Concerns with Oconee Flooding Issue

December 22, 2010

Overview: Adequate Protection Issue

Duke/Law PMP Hydrograph

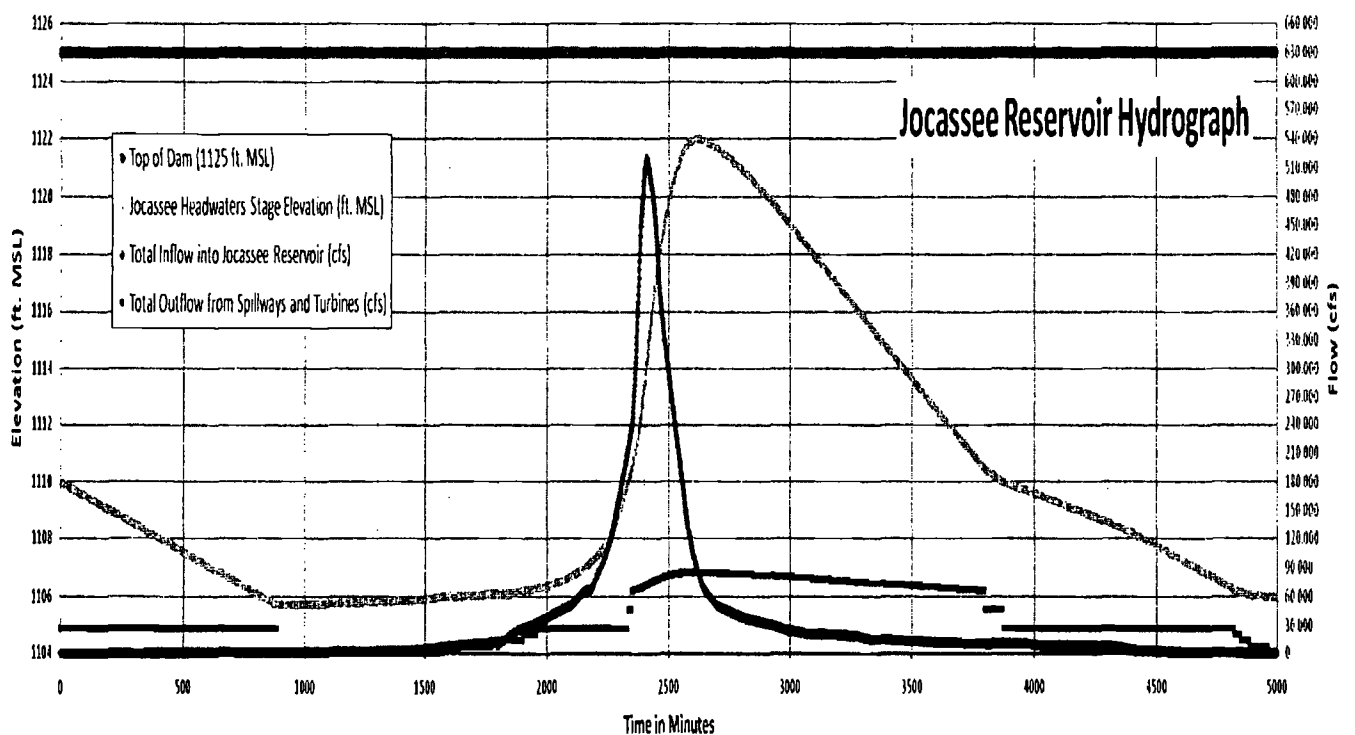
Duke's only analysis of record shows that level can go above 1110

DRA Analysis of 40% of PMP Storm

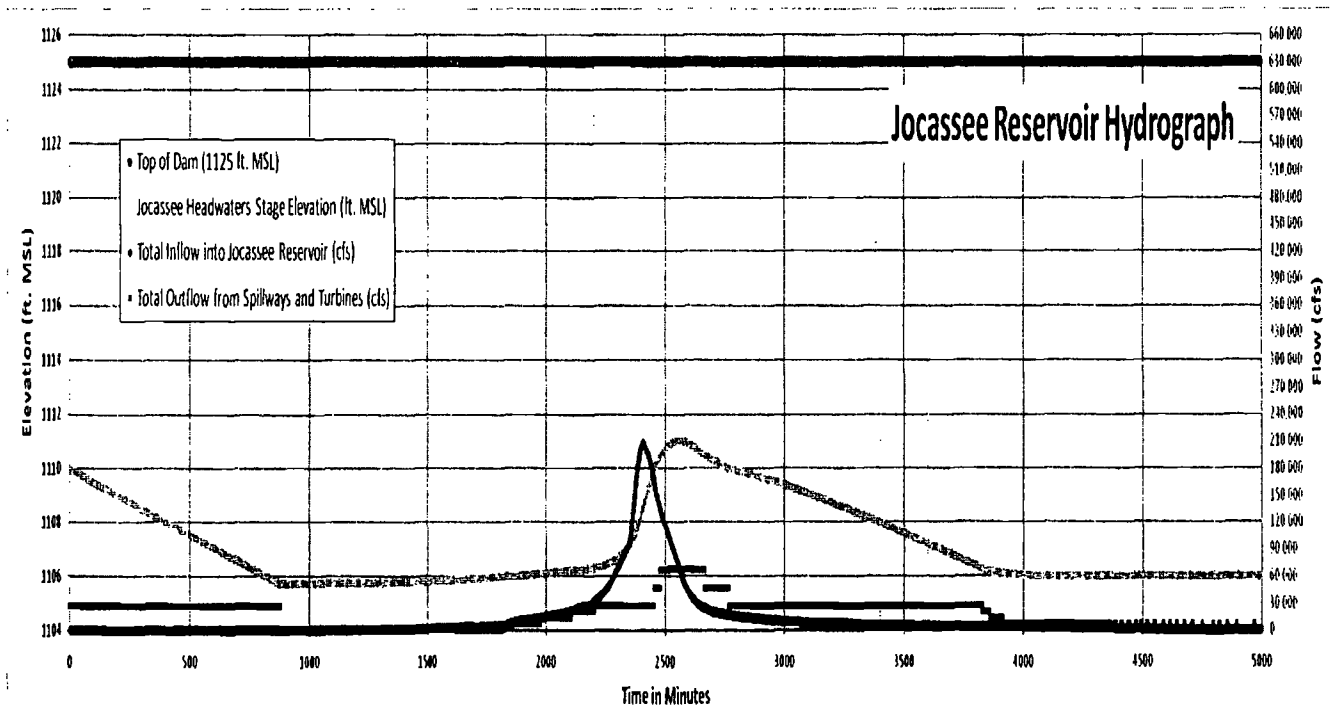
- Turbines available and credited
- Spillways available and credited
- Max water level = 1111 ft. msl
- Any storm greater than 40% of PMP will have water levels above 1110 ft. msl

DRA Analysis of 30% PMP without Turbines

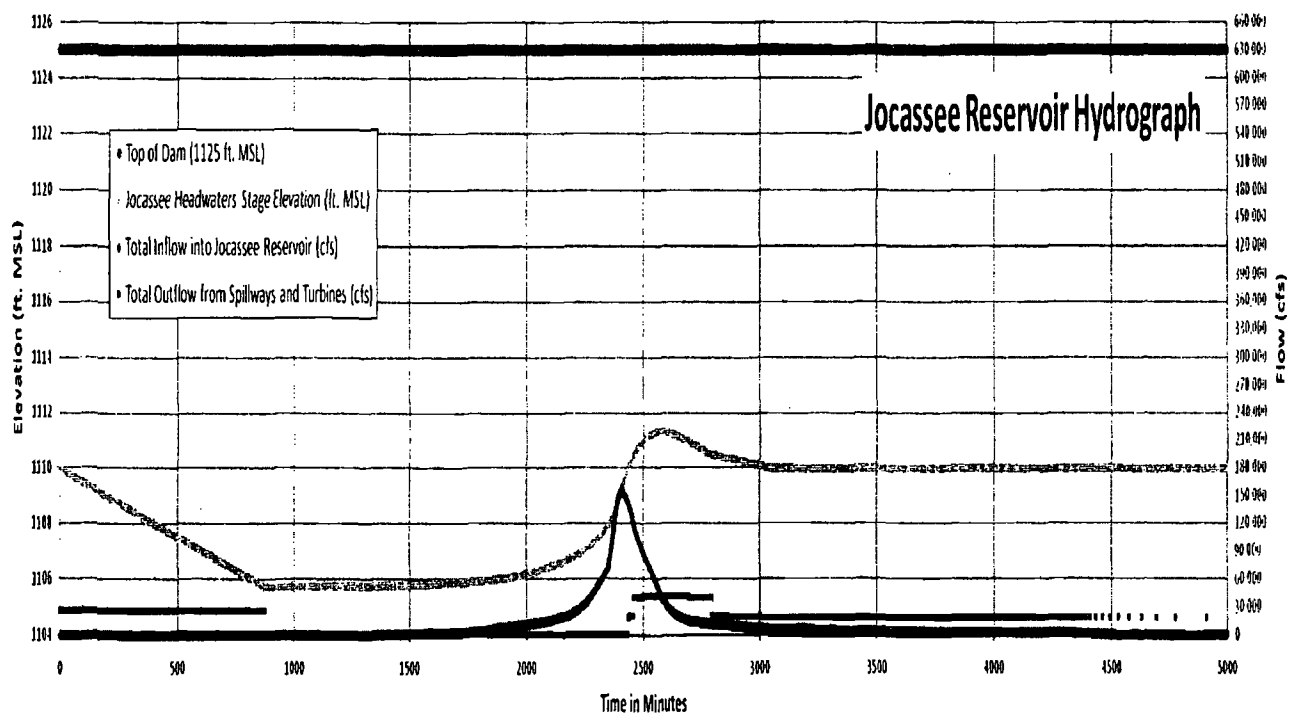
- Turbine available early
- Turbines assumed to fail as storm intensifies
 - Typical turbines cannot be run unloaded
 - Requires generator available
 - Generator requires grid available
 - Availability of grid during a PMP is questionable
- Spillways available and credited
- Max water level = 1111 ft. msl

Conclusion 1110 is not bounding

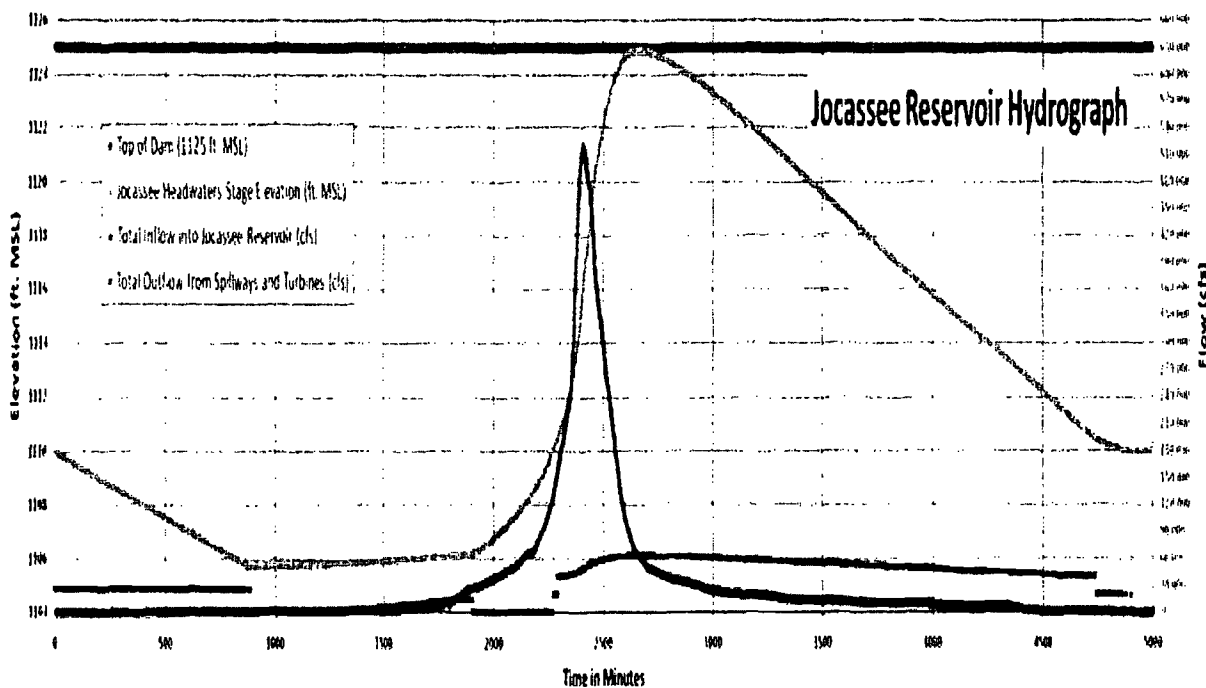
- Duke's PMP analysis of record clearly indicates that water level can exceed 1110
- Comparatively "small" storm (40% of PMP) indicates level will exceed 1110 with max outflow from turbines and spillways
- In my opinion this demonstrates that 1110 is not conservative and not bounding value
- Note: these are not "sunny day" failures

DRA Analysis of PMP without Turbines

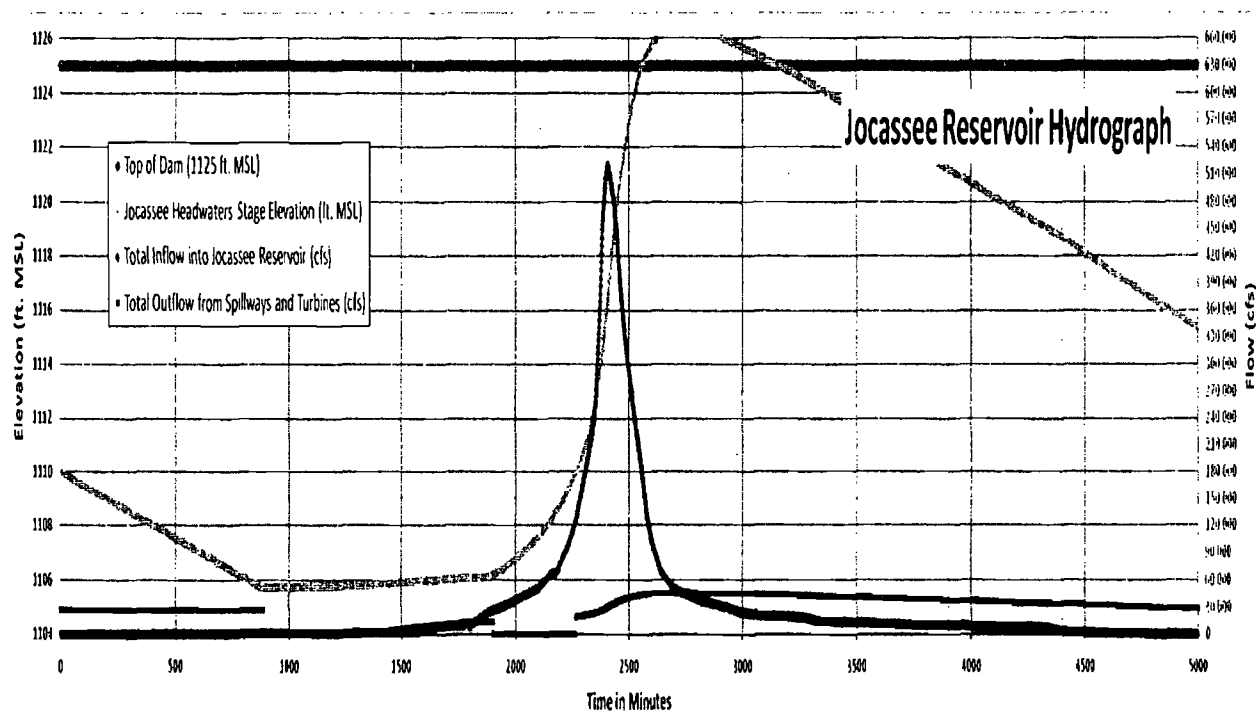
- Turbines available early
- Turbines assumed to fail as storm intensifies – this is highly likely scenario
 - Typical turbines cannot be run unloaded
 - Requires generator available
 - Generator requires grid available
 - Availability of grid during a PMP is questionable
- Both spillways available
- Max water level = 1124.9 ft. msl
- **No margin for uncertainty**
